PROJECT TITLE: Acropolis Parking Structure ZONE MAP/DRG. FILE #: K-14/D74
 DRB #: _____ EPC#: _____ WORK ORDER#: _____

**RE: RESPONSE TO COMMENTS DATED FEBRUARY 7, 2000
ACROPOLIS PARKING STRUCTURE
ALBUQUERQUE, NEW MEXICO**

February 7, 2000

RE: Acropolis Parking Structure(K-14/D074)

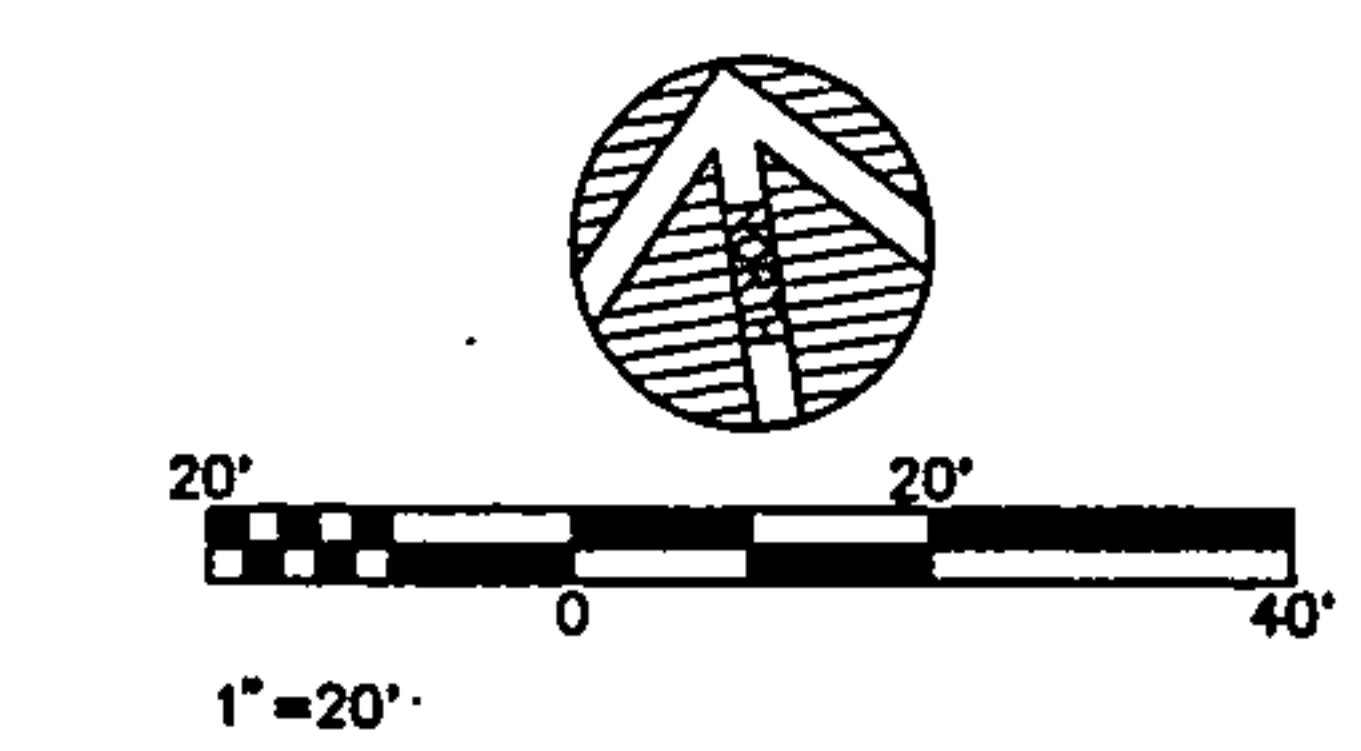
1. PAINT 4" WIDE WHITE STRIPE PER COA STDS.
2. PAINT 6" WHITE ARROW PER COA STDS.
3. ADJUST TOP OF CONTROL BOXES TO NEW GRADE.
4. RELOCATE WAST ARM 6.5' NORTH & 15' EAST WITH COA STD DWG 2526. (3'x3') SEE PLAN.

5. CONSTRUCT 4" TREE WELL IN SIDEWALK PER COA STDS.
6. PAINT 4" DOUBLE YELLOW STRIPE
7. RELOCATE PEDESTAL 9.5' EAST WITH COA STD DWG 2525. (2'x2'x4") SEE PLAN.

8. RELOCATE LIGHT POLE 4' NORTH & 10' WEST, SEE PLAN.
9. RELOCATE LIGHT POLE 5.8' SOUTH & 2.8' WEST, SEE PLAN.
10. RELOCATE LIGHT POLE 5' NORTH & 5' WEST, SEE PLAN.

11. CONSTRUCT BRICK SIDEWALK TO MATCH LA POSADA.
12. CONSTRUCT 6" WIDE HEADER CURB PER COA STD DWG 2445.
13. RELOCATE FIRE HYDRANT NORTH PER COA STD DWG 2340.

14. CONSTRUCT NEW HC RAMP PER COA STD DWG 2426.
15. CONSTRUCT HC RAMP PER COA STD 2441.
16. CONSTRUCT NEW VALLEY GUTTER PER COA STD DWG 2420.
17. EXISTING BRICK PAVERS.

18. REPAVE LOADING LANE PER COA STD 2407.
19. SIDEWALK IS FLUSH WITH STRUCTURE EXT.
20. PAINT 4" YELLOW STRIPES WITH 4" YELLOW STRIPES AT 20' O.C. AT 45' IN BETWEEN.

21. SHOWN FOR CONCEPTUAL PURPOSES ONLY.
22. 24" SOLID WHITE STOP BAR.
23. 12" SOLID WHITE CROSS WALK.
24. INSTALL "NO PARKING ANYTIME" SIGN PER MUTCD R-7-1.

25. PAINT "NO PARKING" ZONE WITH 4" YELLOW STRIPES AT 45' AT 8' O.C. PAINT CURB YELLOW.
